**TOWER 2, LEVEL 23
DARLING PARK, 201 SUSSEX ST
SYDNEY NSW 2000**

S96 MODIFICATION OF SSD 6454 REDLANDS SENIOR SCHOOL CAMPUS CONCEPT PLAN & STAGE 1 WORKS 272 MILITARY ROAD, CREMORNE

This Environmental Impact Statement (EIS) has been prepared by Urbis on behalf of SCECGS Redlands (the Proponent) to accompany a section 96(1A) modification of State Significant Development Approval SSD 6454 (the Approval).

Picture 1 – Roof overhang as approved

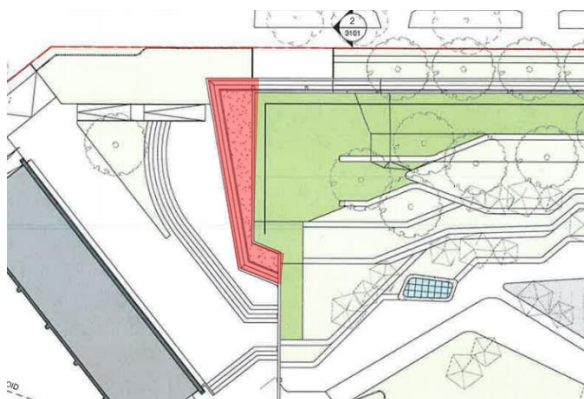
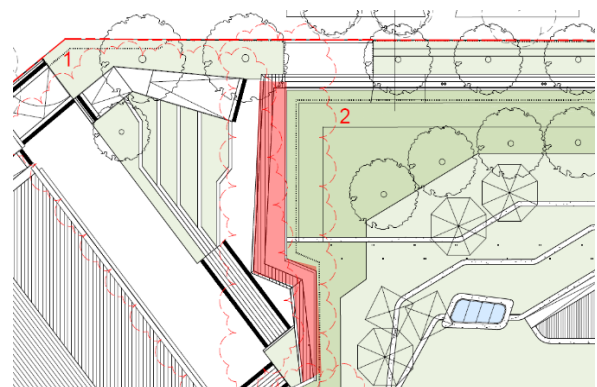
- Relocation of mechanical plant previously located on the eastern side of the podium garden to the eastern edge of the podium;
- Modification of the extent, profile and depth and of the roof overhang to the west elevation of the New Learning Hub;
- Replacement of glazing to the west elevation of the Interim Music Hub at the basement level with solid wall;
- Minor increase (100mm) in the height of the window sill at basement level to the north elevation of the Interim Music Hub;
- Minor modifications to the entry forecourt including changes to the ramp and stair configuration;
- Minor modifications to circulation routes and seating configurations.

MODIFICATION	COMMENT
Relocation of mechanical plant	The proposed modifications will improve the acoustic and visual amenity of the trafficable Music Hub rooftop while relocating the plant to a services area where it will have minimal impact.
Modification of the extent, profile and depth and of the roof overhang	The proposed modifications will provide a clearly defined entry point, improved weather protection as well as a more cohesive presentation integrated with the landscape form above.
Replacement of foyer glazing to with solid wall	<p>The proposed modifications will provide an improved transition along the adjoining stair in response to landscape changes.</p> <p>The modification will improve building performance in terms of thermal efficiency with minimal impact to natural solar access due to the location of the glazing alongside corridor space.</p>
Minor increase in basement level window sill height	The proposed modifications will raise the sill height by 100mm to reflect the raised level of the front setback that has, in turn, been raised to alleviate flood risk.

Picture 3 – Location of Mechanical Plant as approved and modified

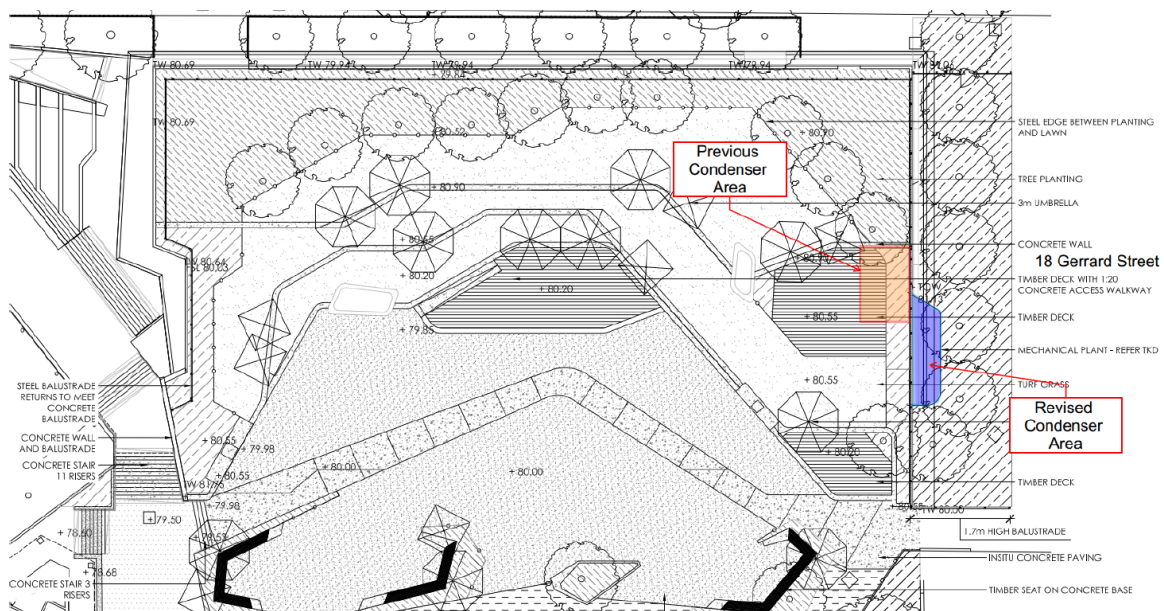
An assessment of the revised mechanical plant location within the podium structure has been prepared by Wilkinson Murray regarding the site-specific noise criteria specified by the Approval.

- The condenser plant is in a plant area that is contained in the new facility carpark below ground level. Noise from the condenser intakes will be contained to the inside of the carpark.
- The outlets of the condensers have 2D circular silencer installed on top of the units.
- Internal walls are to be lined with acoustic absorption material
- The condenser units that may operate in the evening are to be set on night mode to further reduce noise generated by the units.

Picture 4 – Entry forecourt design as approved

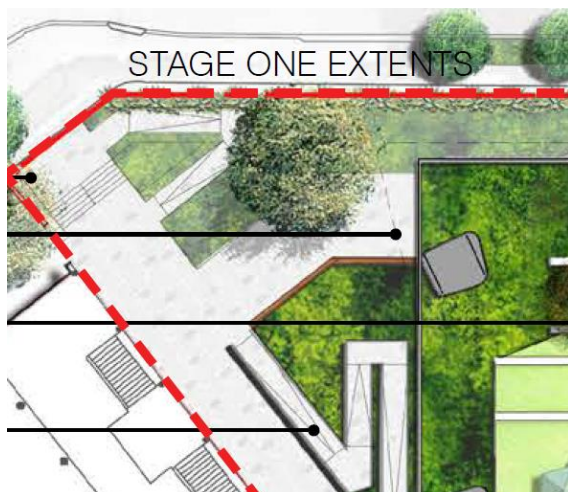
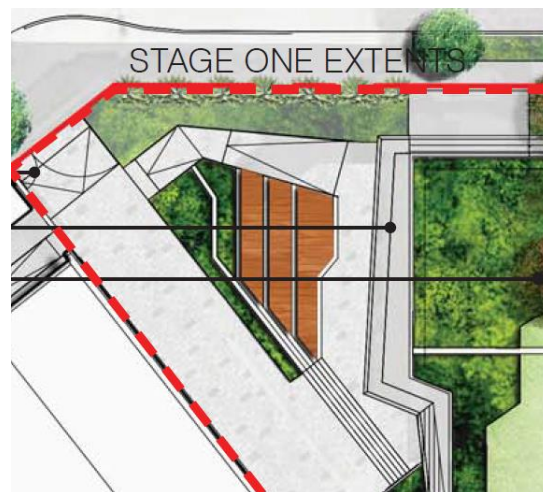
Minor modifications to the entry forecourt	The proposed modifications will improve circulation and provide informal bleacher style seating for staff and students through the incorporation of terracing.
Reconfiguration of podium and rooftop landscaped areas	<p>Changes are proposed to rationalise circulation routes and create greater flexibility and variety of open spaces. The modifications will also achieve a modest increase in deep soil area.</p> <p>Although modifications are proposed to the location of new and replacement tree plantings, the number of new trees proposed for the site is unchanged.</p>
